**Economic and Social Council**Distr.: General
28 February 2018

Economic Commission for Europe**Inland Transport Committee****World Forum for Harmonization of Vehicle Regulations****Working Party on Passive Safety****Sixty-third session**

UN Global Technical Regulation No. 9 (Pedestrian safety)**Proposal for Amendment 2 (Phase 2)****Submitted by the Informal Working Group on UN Global Technical Regulation No. 9***

"Figure 5A

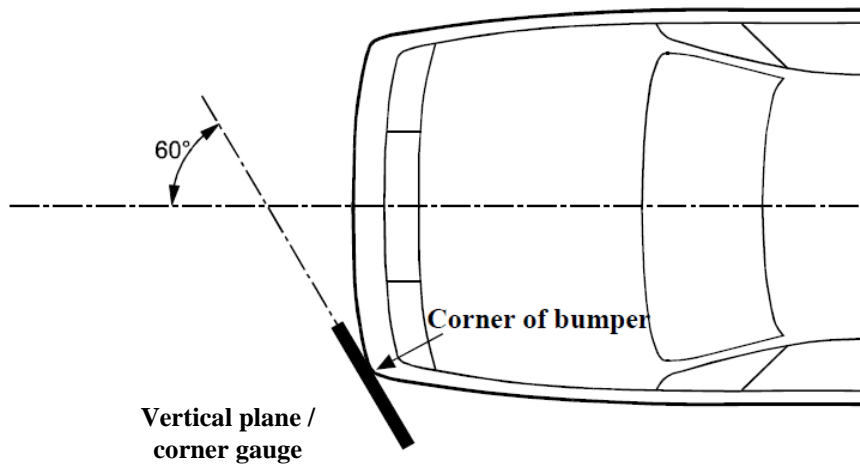
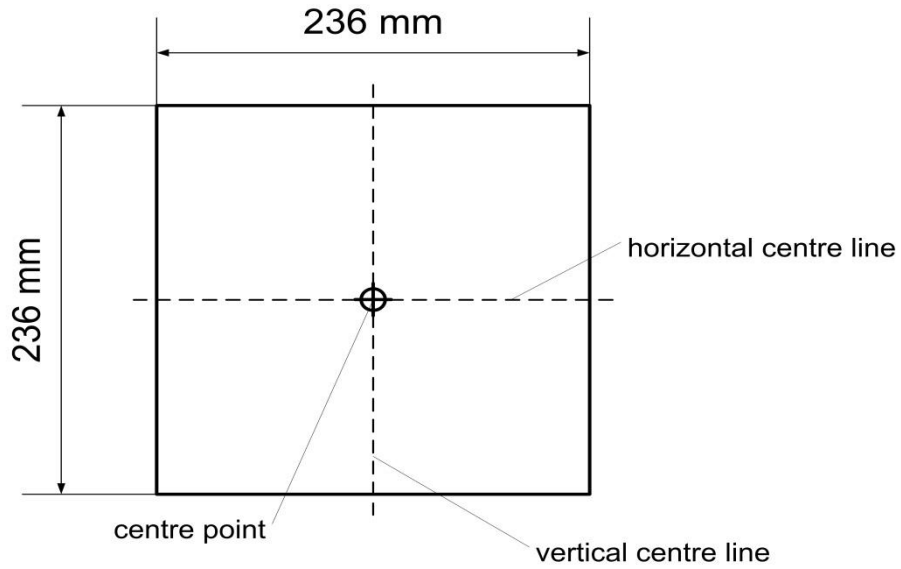
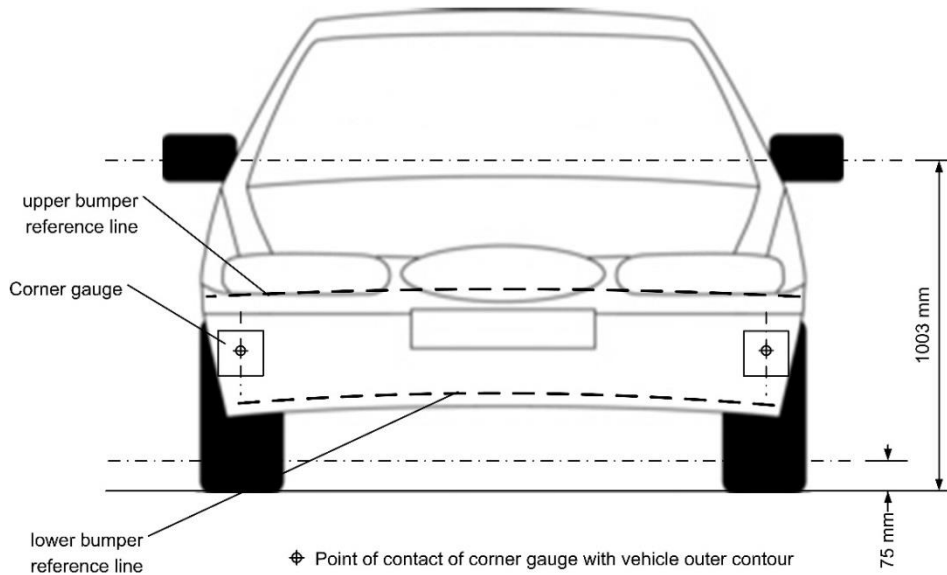
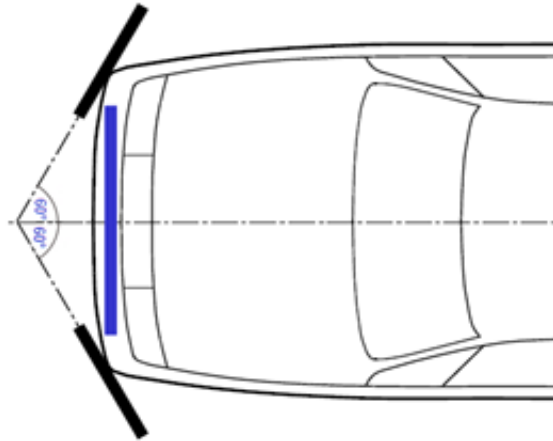
"3.14. **"Corner of bumper"** means **the transversal position of the vehicle's point of contact with a vertical plane which makes an angle of 60° with the vertical longitudinal plane of the vehicle and is tangential to the outer surface of the bumper (see Figure 5)-corner gauge as defined in Figure 5B.**

For determination of the corner of bumper, the front surface of the corner gauge is moved parallel to a vertical plane with an angle of 60° to the vertical longitudinal centre plane of the vehicle (see Figures 5A and 5C) at any height of the centre point of the corner gauge between:

- (a) **Equal to and above the point found on the vertical line intersecting the Lower Bumper Reference Line at the assessment position in transversal direction or at 75 mm above the ground reference plane, whichever is higher.**
- (b) **Equal to and below the point found on the vertical line intersecting the Upper Bumper Reference Line at the assessment position in transversal direction or at 1,003 mm above the ground reference plane, whichever is lower.**

For determination of the corner of bumper, the gauge is moved to contact the outer contour/front fascia of the vehicle touching at the vertical centre line of the gauge. The horizontal centre line of the gauge is kept parallel to the ground plane.

Flexible lower legform impactor: Dimensions and centre of gravity locations of femur, knee joint and tibia (side view)

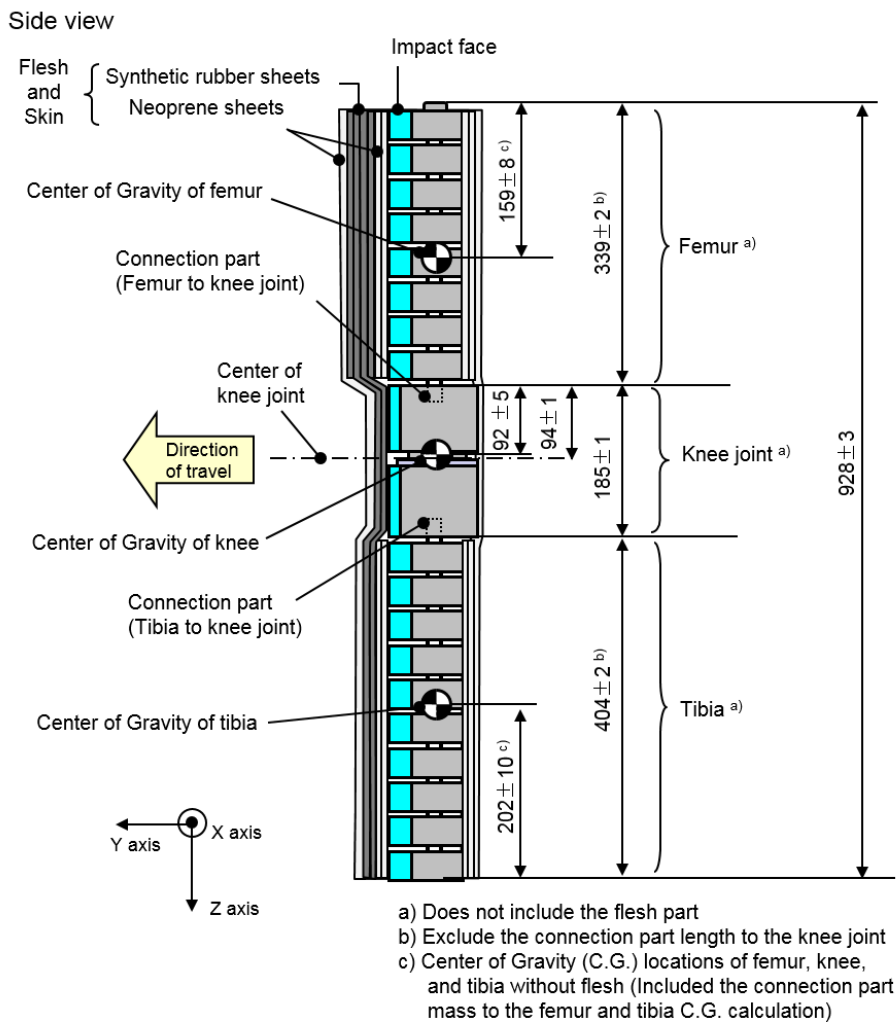
The flexible lower legform impactor shall consist of the flesh and skin, flexible long bone segments (representing femur bone and tibia bone), and the knee joint as shown in Figure 12.²

The assembled impactor shall have a total mass of $13.2 \pm \{0.4 \text{ kg}\}$. The dimensions of the fully assembled impactor shall be as defined in Figure 12, measured at the vertical centre line.

The centres of gravity of the femur and tibia without the flesh and skin, including the connection parts to the knee joint, shall be as defined in Figure 12. The centre of gravity of the knee joint shall be as defined in Figure 12.

Figure 13
Flexible lower legform impactor: Schematic plan views of femur, tibia, and knee dimensions (top view, main body segments)

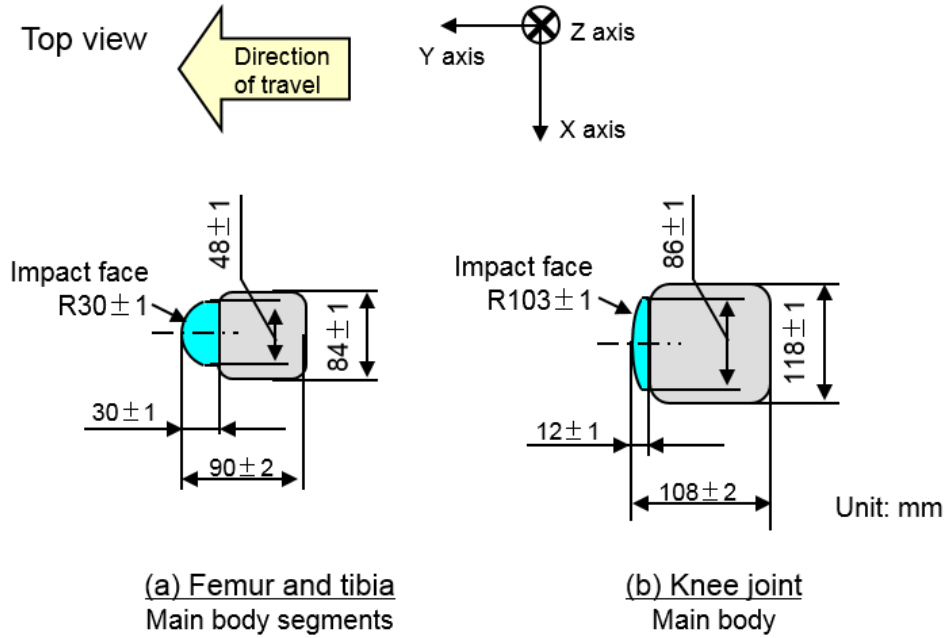
"6.3.1.1.1. **The cross-sectional shape of the femur main body segments, the tibia main body segments and their impact faces shall be as defined in Figure 13 (a).**

- 6.3.1.1.2. **The cross-sectional shape of the knee joint and its impact face shall be as defined in Figure 13 (b).**

Figure 14
Flexible lower legform impactor: Flesh and skin dimensions

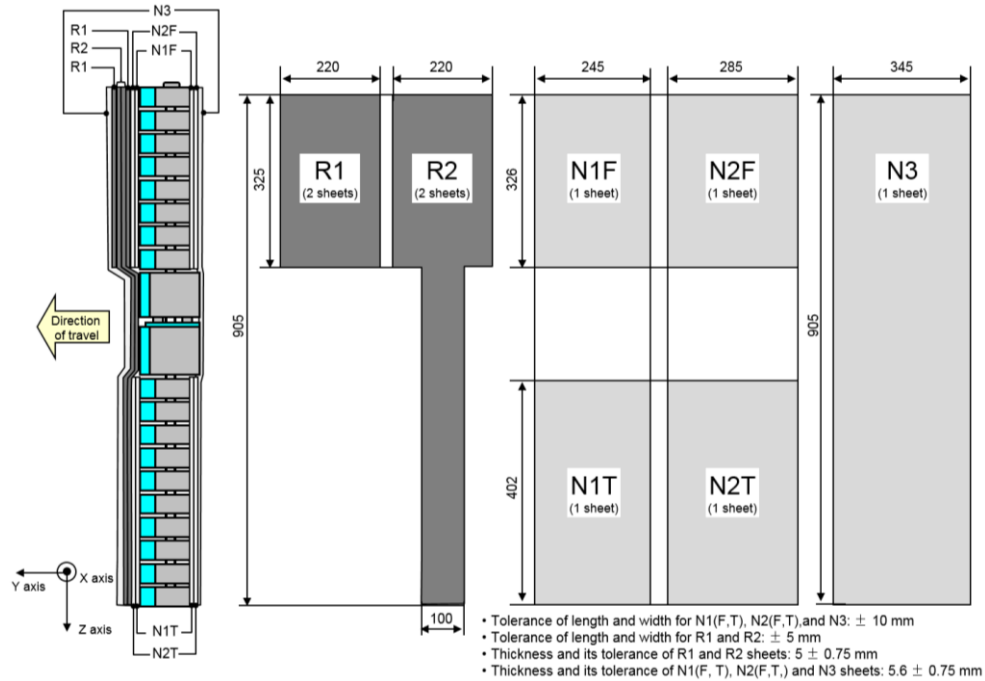
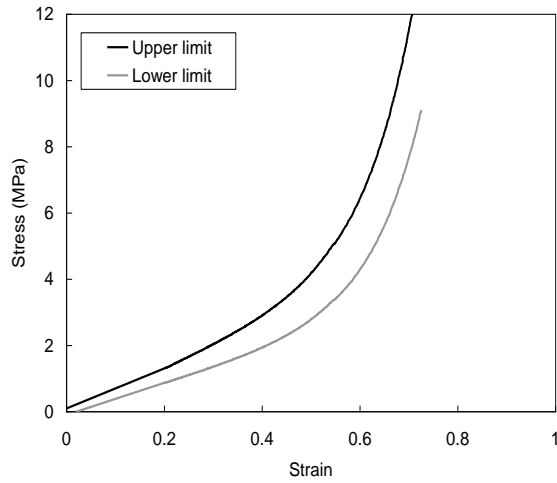
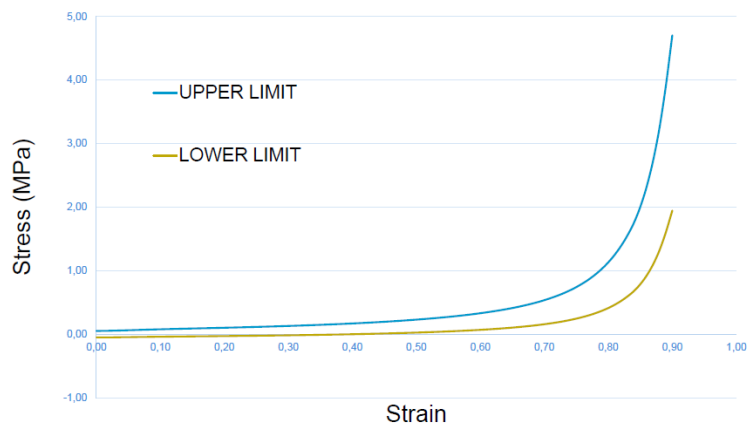
- 6.3.1.1.4. **For each test, the impactor (femur, knee joint and tibia without flesh and skin) shall be covered by the flesh and skin composed of synthetic rubber sheets (R1, R2) and foamed neoprene sheets (N1F, N2F, N1T, N2T, N3) as shown in Figure 14. The size of the sheets shall be within the requirements described in Figure 14. The sheets are required to have compression characteristics as shown in Figure 15. The compression characteristics shall be checked using material from the same batch as the sheets used for the impactor flesh and skin.**

Figure 16
Flexible lower legform impactor: Location of the transducers

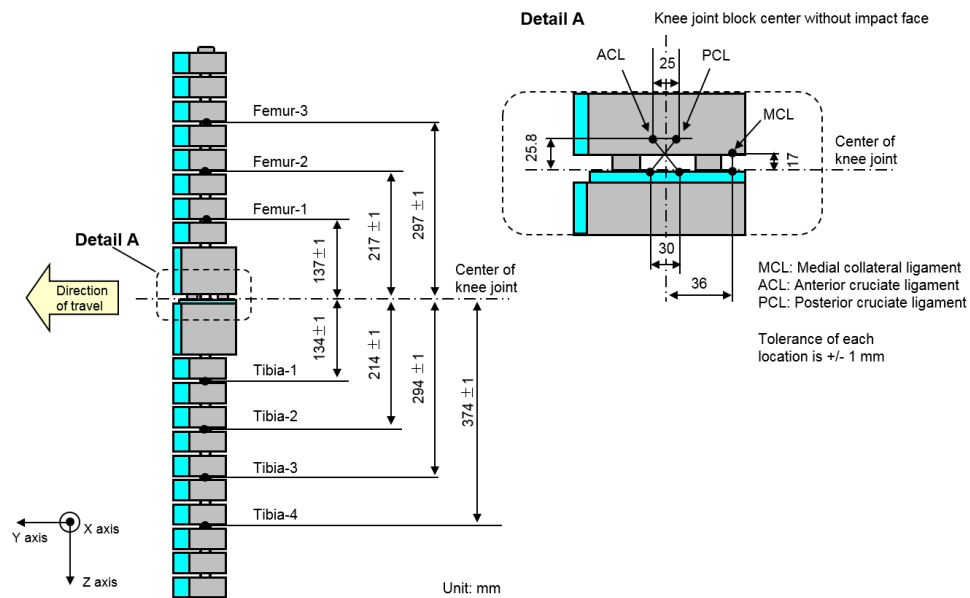
Three transducers shall be installed in the femur to measure bending moments applied to the femur. The sensing locations of each of the transducers are as defined in Figure 16.

6.3.1.1.6.2. **Three transducers shall be installed in the knee joint to measure elongations of the Medial Collateral Ligament (MCL), Anterior Cruciate Ligament (ACL), and Posterior Cruciate Ligament (PCL). The measurement locations of each transducer are shown in Figure 16. The measurement locations shall be within ± 4 mm along the X-axis from the knee joint centre.**

"Figure 20

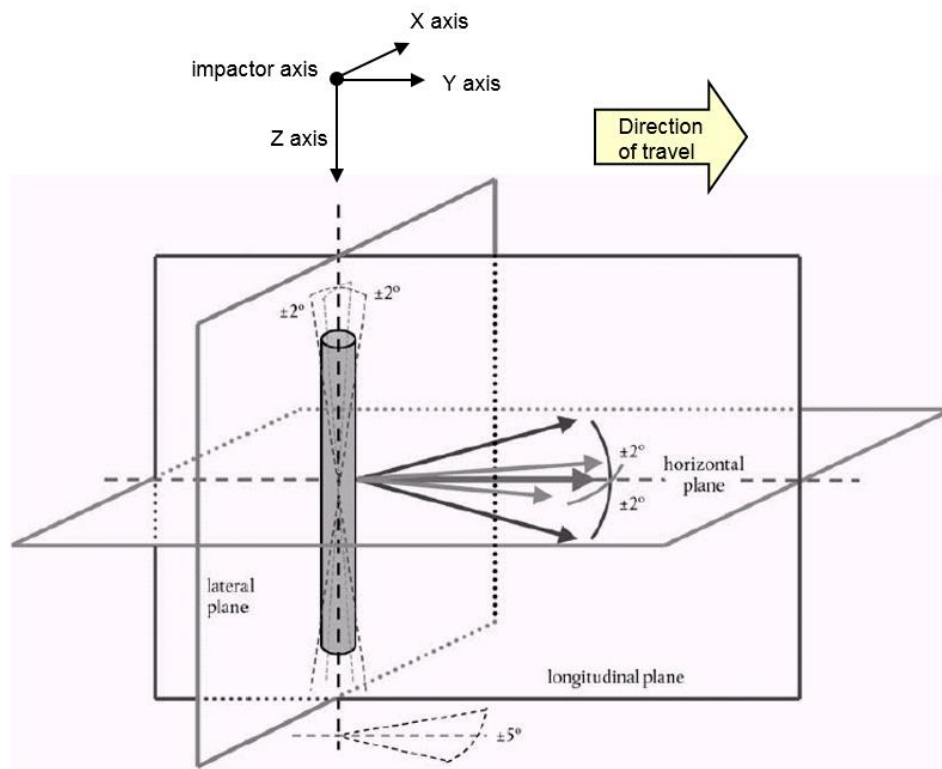
7.1.1.2. **The direction of the impact velocity vector shall be in the horizontal plane and parallel to the longitudinal vertical plane of the vehicle. The tolerance for the direction of the velocity vector in the horizontal plane and in the longitudinal plane shall be $\pm 2^\circ$ at the time of first contact. The axis of the impactor shall be perpendicular to the horizontal plane, with a roll and pitch angle tolerance of $\pm 2^\circ$ in the lateral and longitudinal plane. The horizontal, longitudinal and lateral planes are orthogonal to each other (see Figure 20).**

- 7.1.1.3.2. **At the time of first contact the impactor shall have the intended orientation about its vertical axis, for the correct operation of its knee joint, with a yaw angle tolerance of $\pm 5^\circ$ (see Figure 20).**

Figure 21

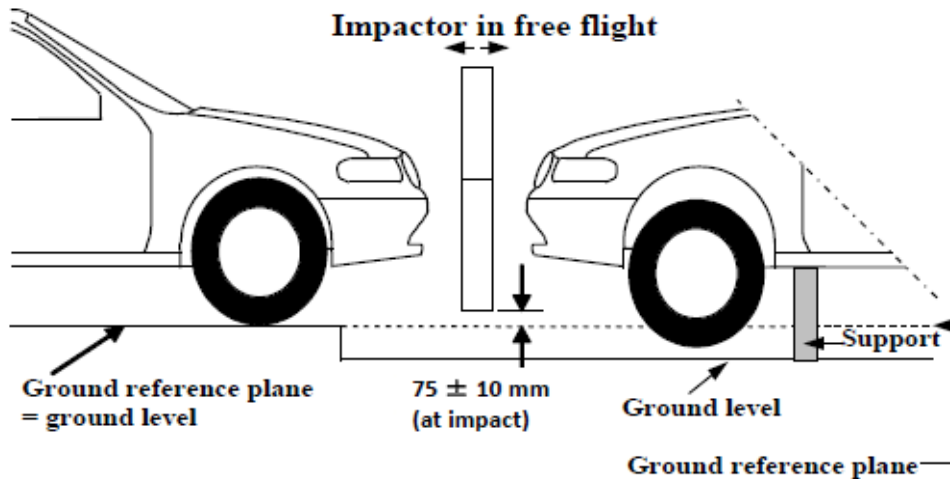
7.1.1.3. **The bottom of the impactor (without parts needed for the purposes of launching and/or protection) shall be 75 mm above the ground reference plane at the time of the first contact with the bumper (see Figure 21), with a tolerance of ± 10 mm. When setting the height of the propulsion system, an allowance shall be made for the influence of gravity during the period of free flight of the impactor.**

Figure 22

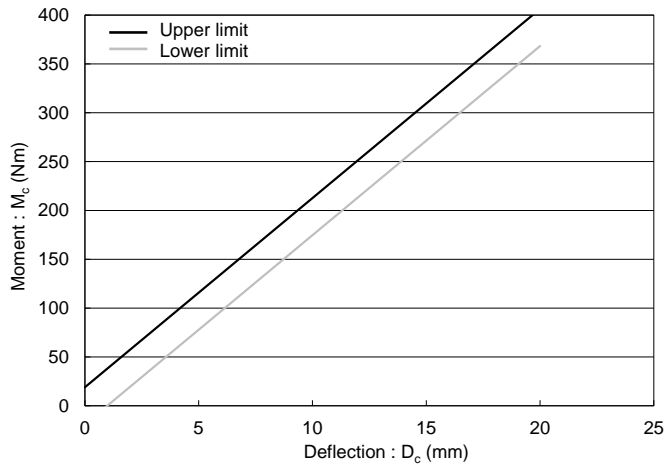
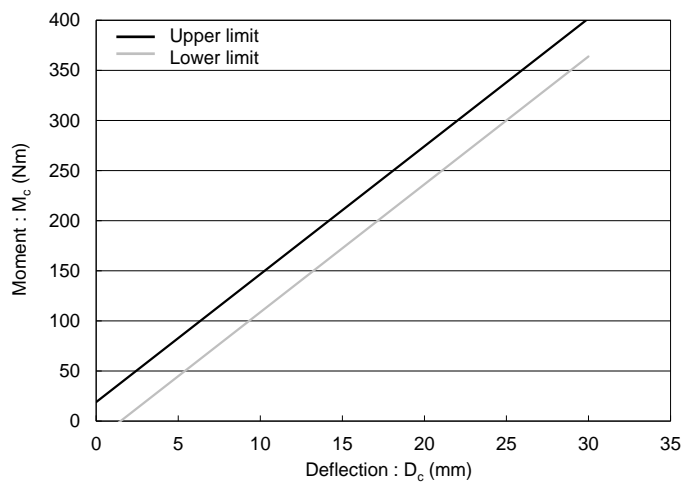
- 8.1.1.2. **When the femur and the tibia of the impactor, without flesh and skin, are loaded in bending in accordance with paragraph 8.1.1.4., the applied moment and the generated deflection at the centre of the femur and the tibia (M_c and D_c) shall be within the corridors shown in Figure 22.**

Figure 23

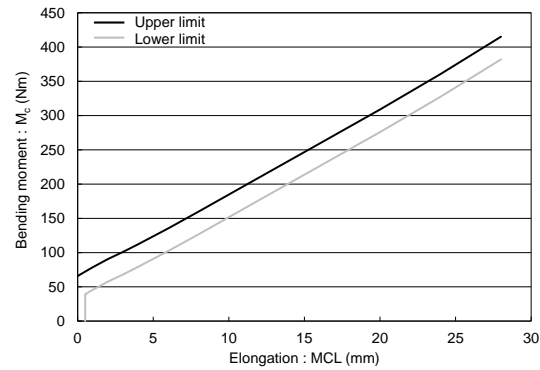
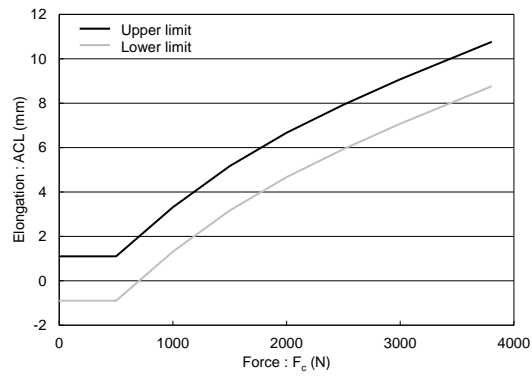
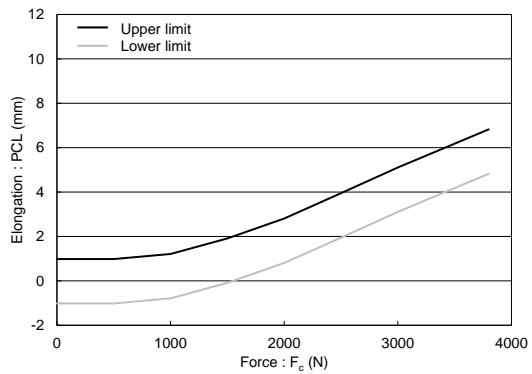
- 8.1.1.3. **When the knee joint of the impactor, without flesh and skin, is loaded in bending in accordance with paragraph 8.1.1.5., the MCL, ACL, and PCL elongations and applied bending moment or the force at the centre of the knee joint (M_c or F_c) shall be within the corridors shown in Figure 23.**

Figure 24
Flexible lower legform impactor: Test set-up for the femur in the static certification test (see paragraph 8.1.1.4.)

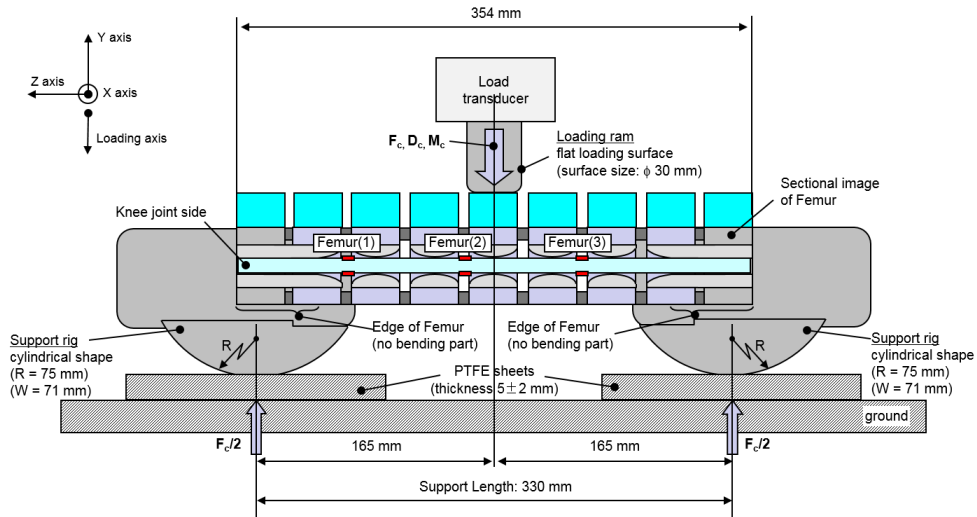
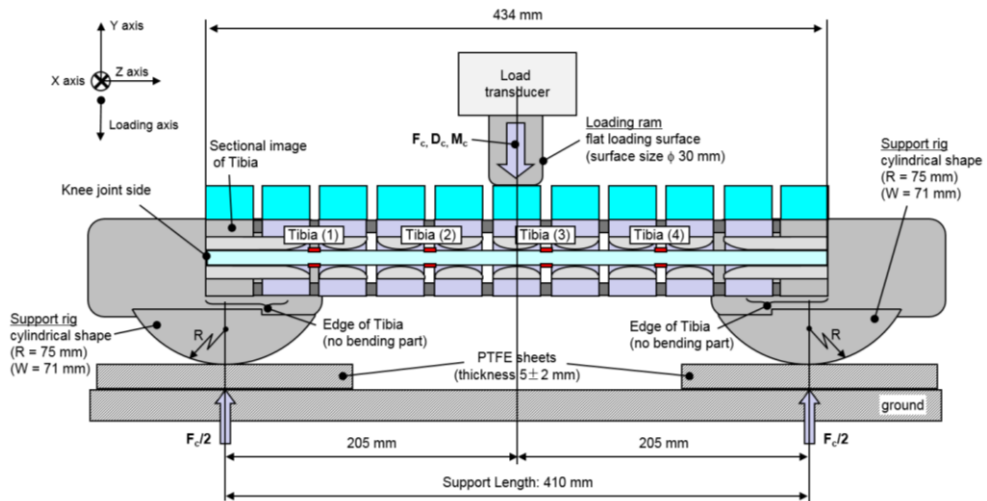
- 8.1.1.4. **The edges of the femur and tibia, without flesh and skin, not bending parts, shall be mounted to the support rig firmly as shown in Figure 24 and Figure 25. The Y-axis of the impactor shall be parallel to the loading axis within $180 \pm 2^\circ$ tolerance. To obtain repeatable loading, low friction Polytetrafluoroethylene (PTFE) plastic pads are used under each support (see Figures 24 and 25).**

Figure 26
Flexible lower legform impactor: Test set-up for the knee joint in the static certification test (see paragraph 8.1.1.5.)

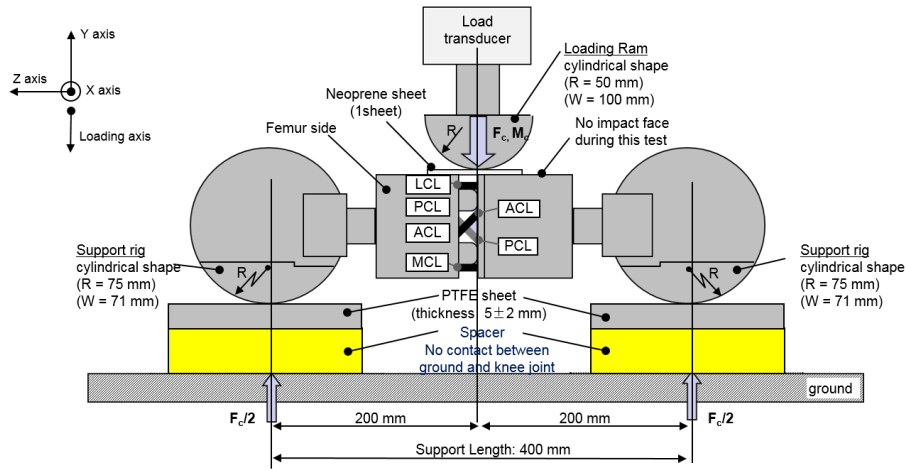
- 8.1.1.5. **The ends of the knee joint, without flesh and skin, shall be mounted to the support rig firmly as shown in Figure 26. The Y-axis of the impactor shall be parallel to the loading axis within $\pm 2^\circ$ tolerance. To obtain repeatable loading, low friction Polytetrafluoroethylene (PTFE) plastic pads are used under each support (see Figure 26). To avoid impactor damage, a foamed neoprene sheet shall be set between the loading ram and the impactor face of the knee joint, which is described in Figure 26, shall be removed. The foamed neoprene sheet used in this test shall have compression characteristics as shown in Figure 15.**

The centre of the loading force shall be applied at the knee joint centre within $\pm 2^\circ$ mm tolerance along the Z-axis (see Figure 12). The external load shall be increased so as to maintain a deflection rate between 10 and 100 mm/minute until the bending moment at the centre part of the knee joint (M_c) reaches 400 Nm.
